Downtown Victoria North Manchester.

RIBA Stage 4 Planning Adjustments
12882-AEW-XX-XX-PP-A-0017

BS / BR 09/02/24
P01

Introduction.

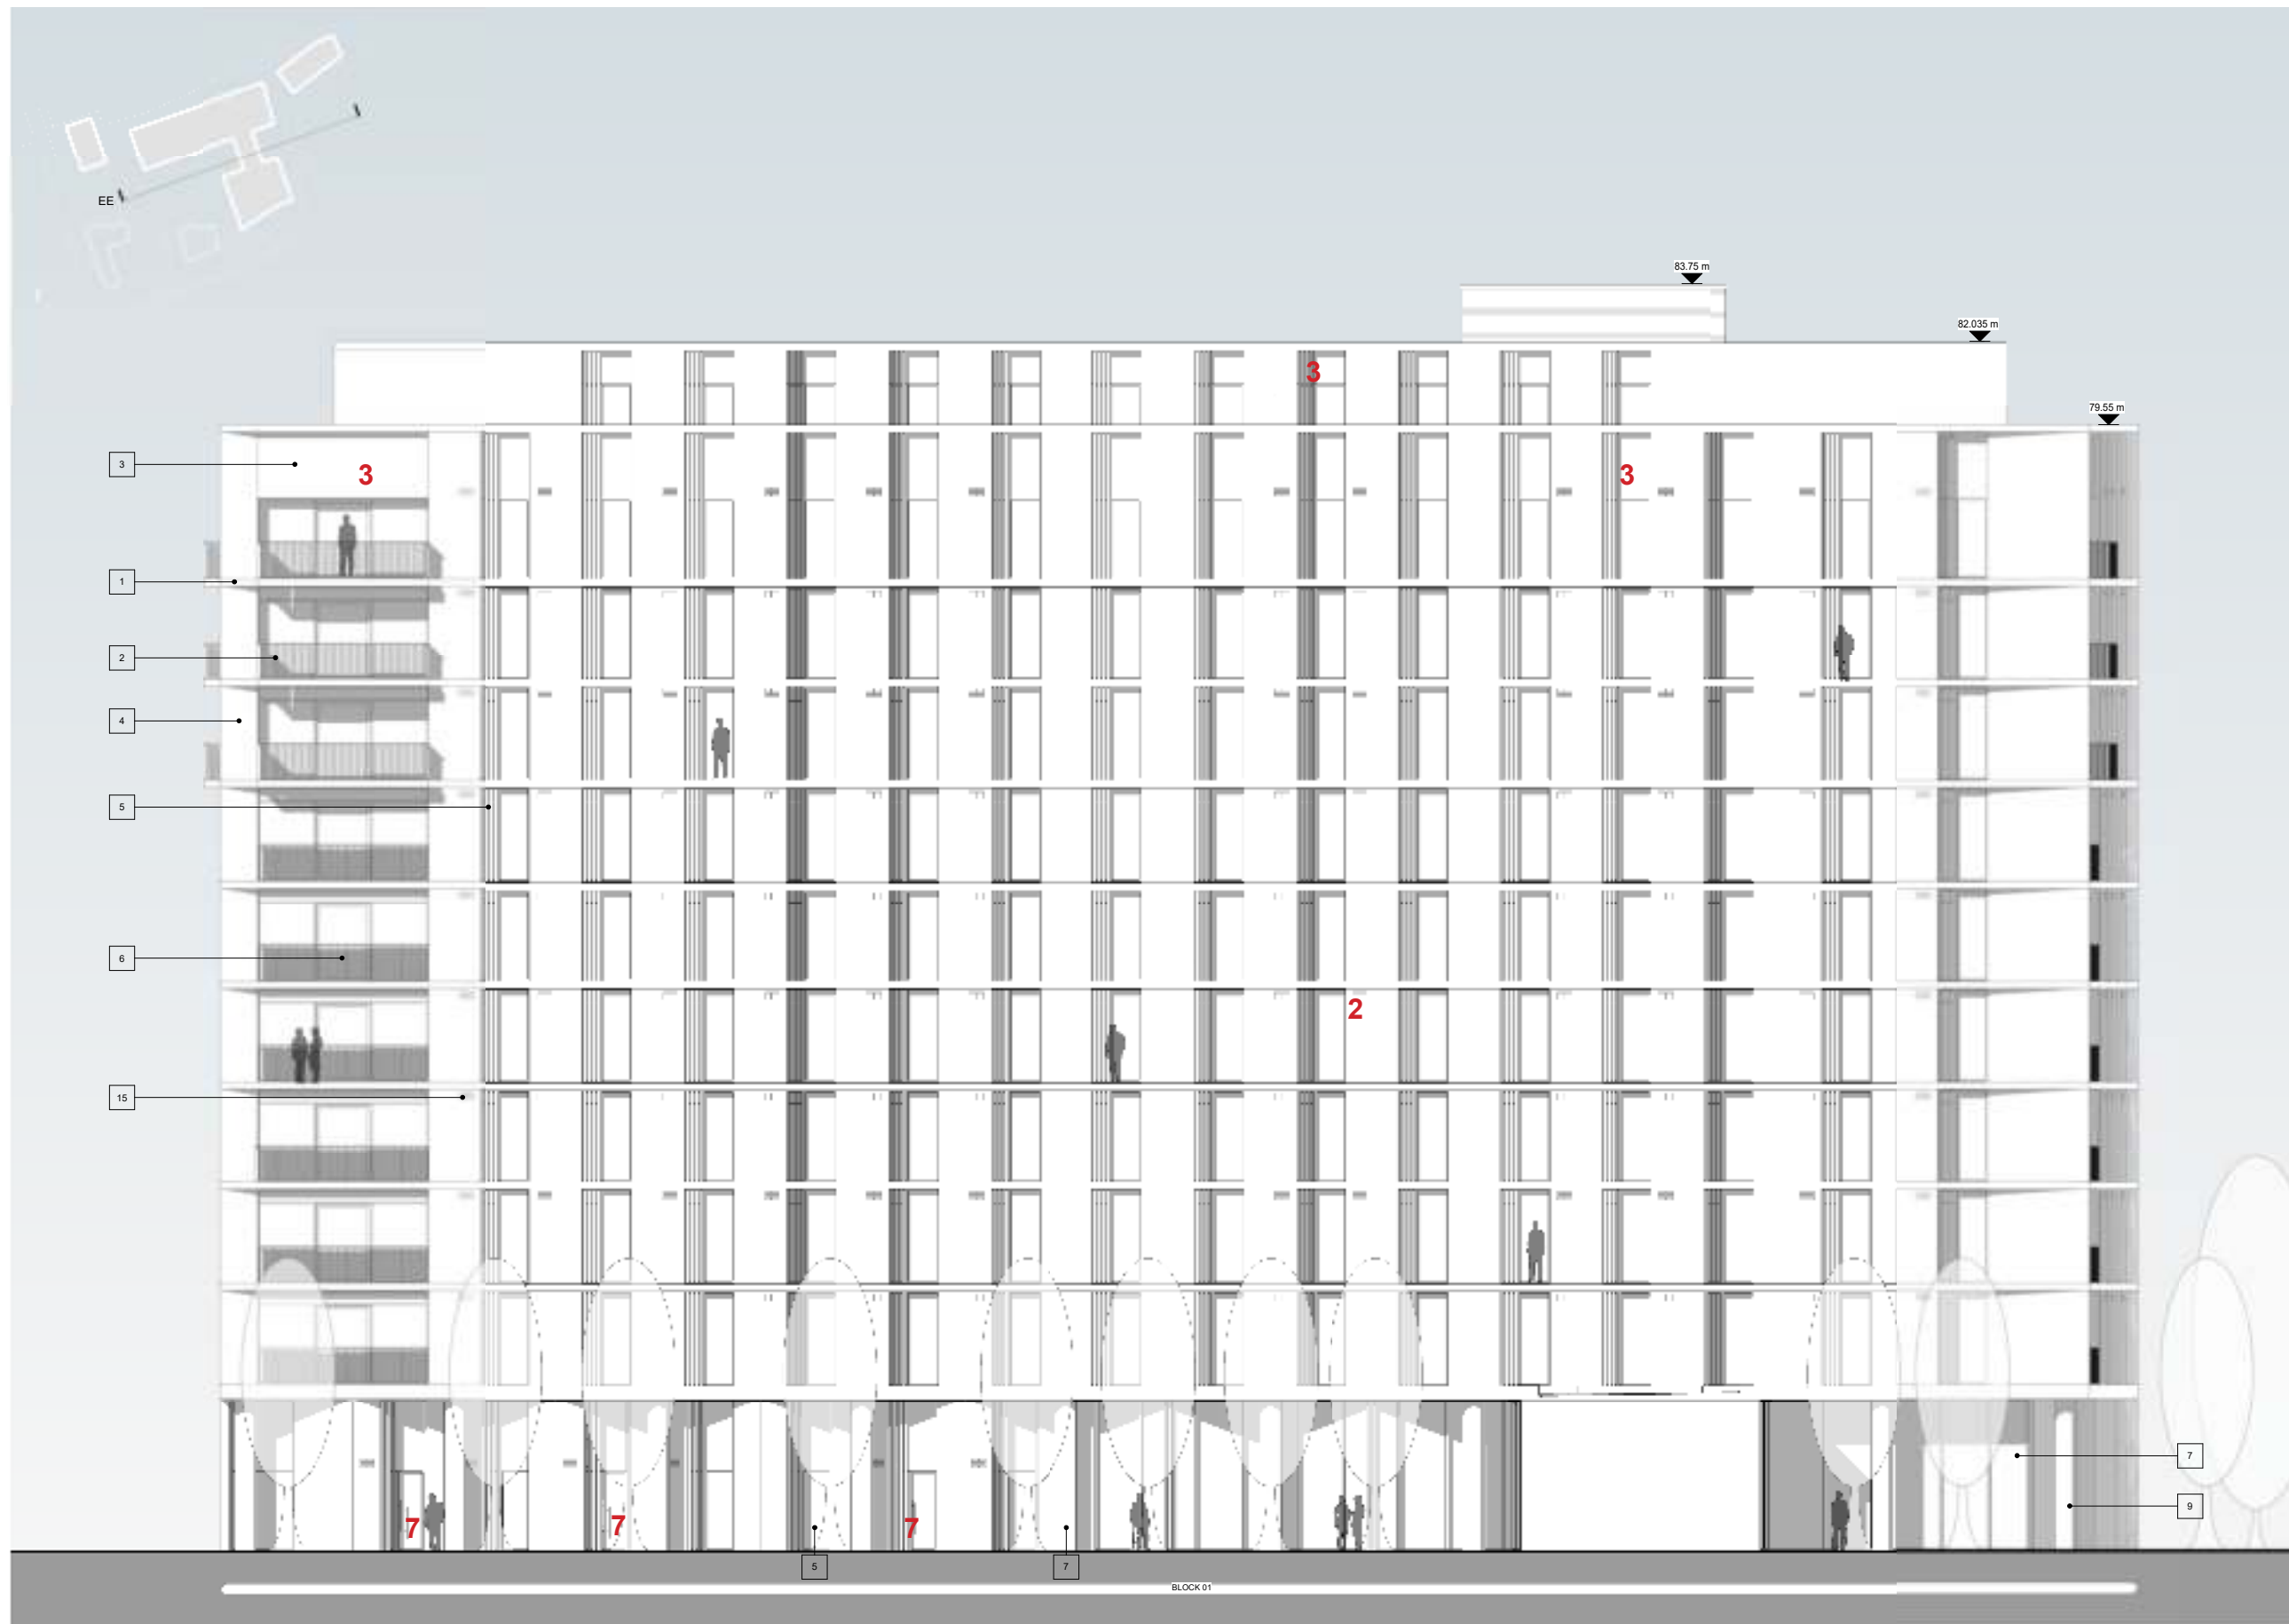
1 Adjustment to base of curtain walling to follow line of raked landscape.

2 Adjustment to airbrick location following development of ventilation strategy

3. For Fire Engineering and CDM purposes, panels to be introduced in back painted glass at mid-floors and rainscreen at roof levels

8 Reconfiguration of Curtain walling to facilitate dry riser inlet

9 Dry Riser inlet added

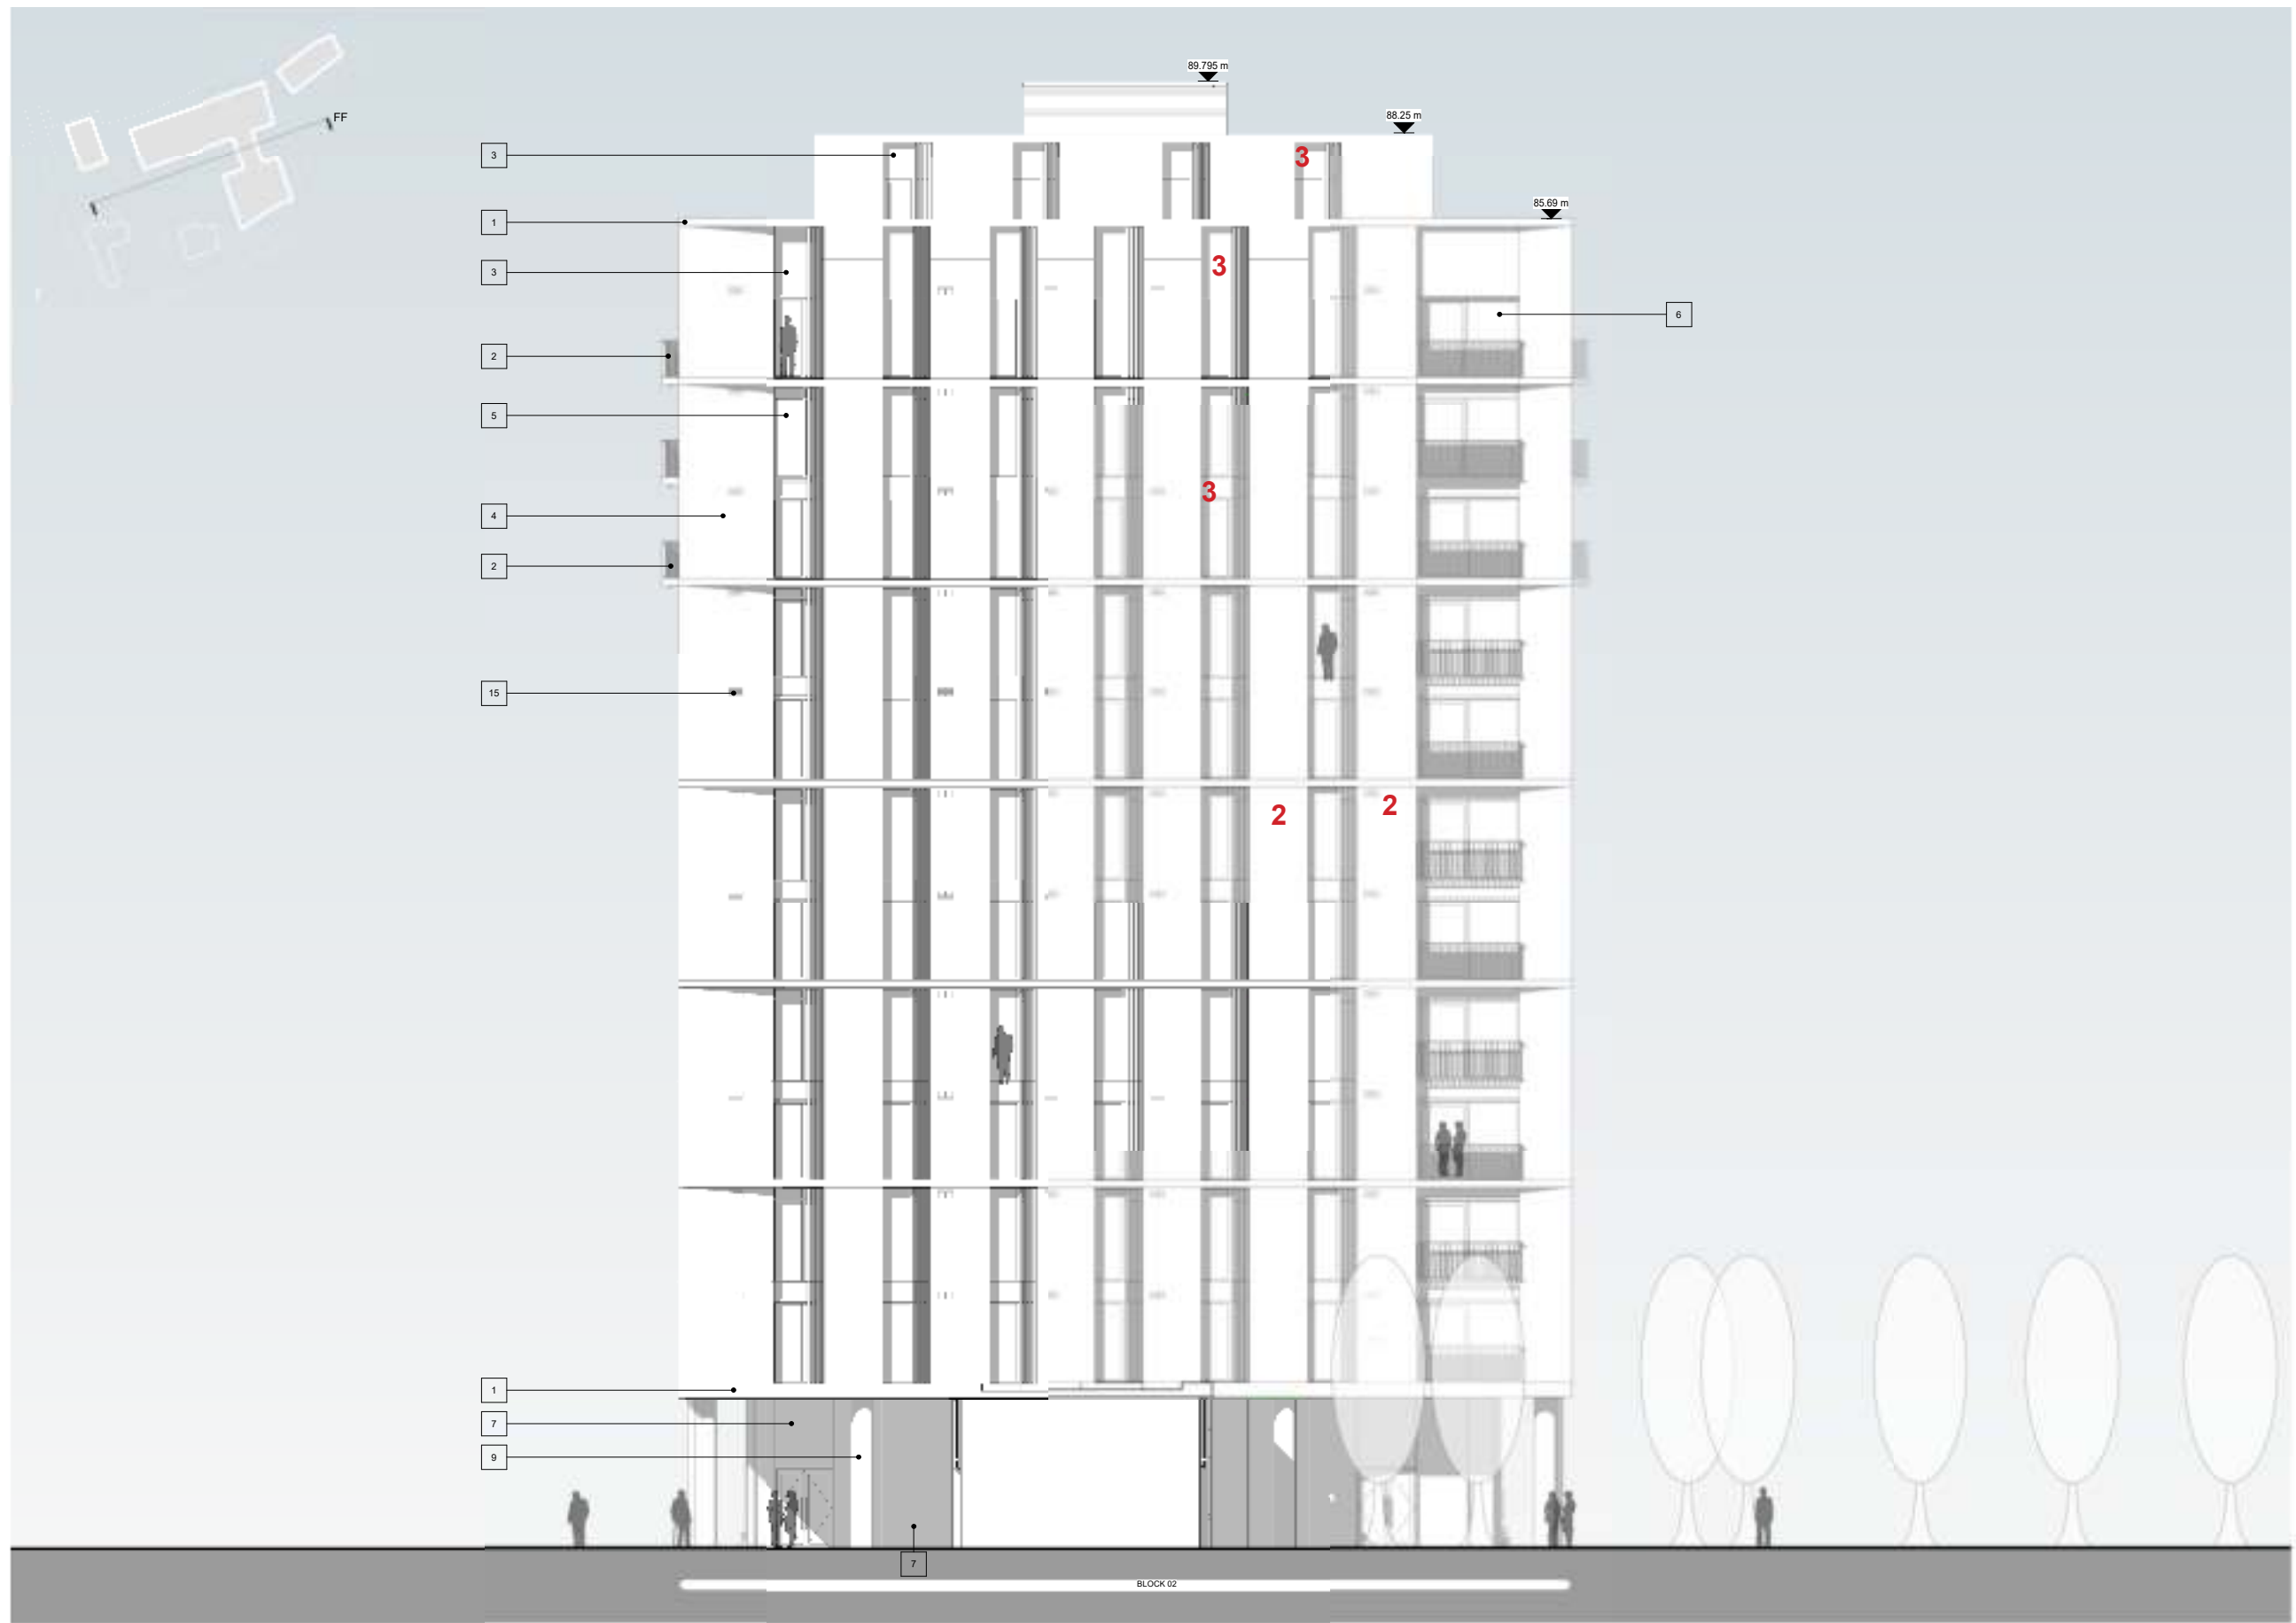
2 Adjustment to airbrick location following development of ventilation strategy

3. For Fire Engineering and CDM purposes, panels to be introduced in back painted glass as rainscreen at roof levels

7 Adjustment of doors following reconfiguration of ground floor

Adjusted Bay Study

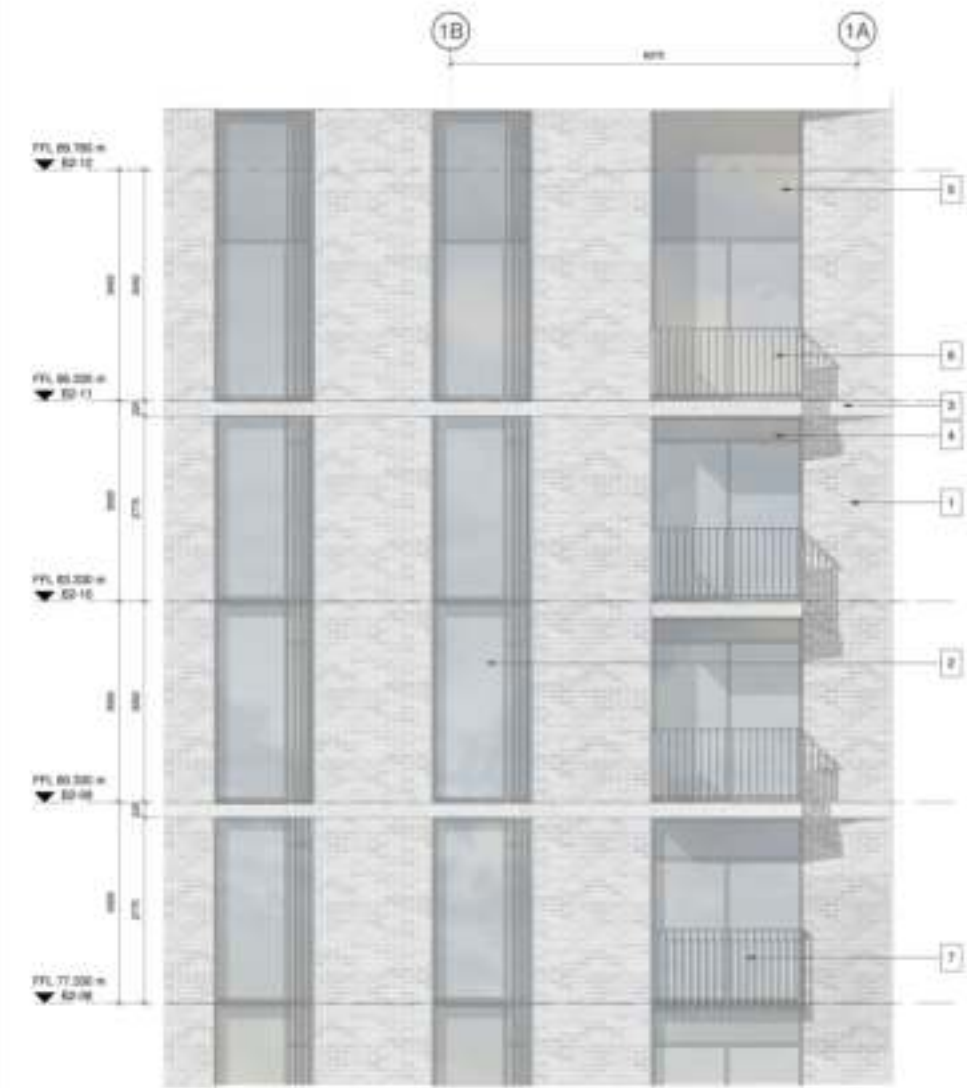
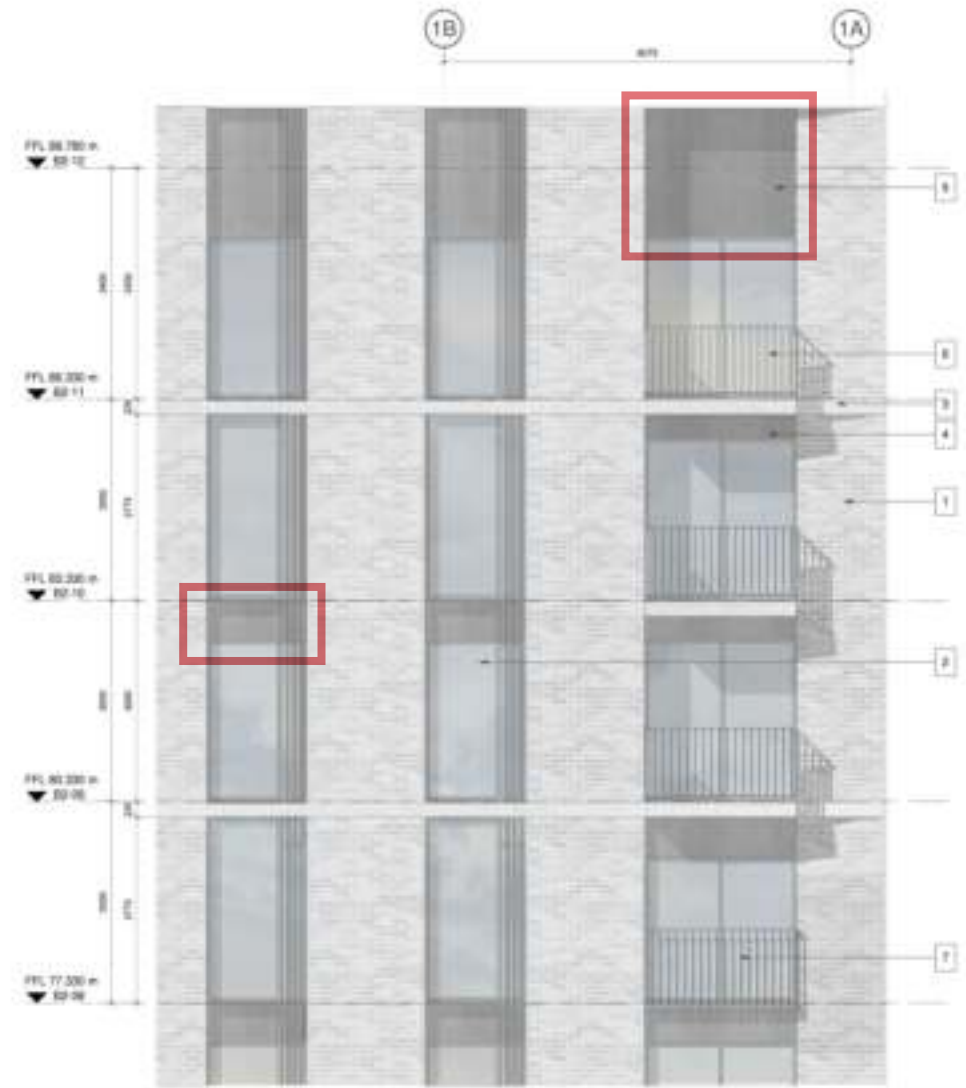
Following the last review of design development matters with MCC Planning Authority the inclusion of double transoms and spandrel to intermediate floors to Block 2 was agreed in principle.

Through further design development we sought the advice of our Fire Engineer at DFC and have been advised that aluminium spandrel panels meet the requirements of Regulation 7 of the Building Regulations.

Regulation 7 of the Building Regulations requires all materials used in the external wall (and specified attachments) to achieve Class A2-s1, d0 or better, other than limited permitted exclusions. All materials include any glazing used in the external wall or its attachments, with exception specifically for glazing in windows. Glazing in other applications, such as spandrels and balustrades is not excluded, therefore the glazing in this spandrel must achieve Class A2-s1, d0.

For the above reason we also propose that the large panels at parapet level are replaced with the proposed back painted glass panels.
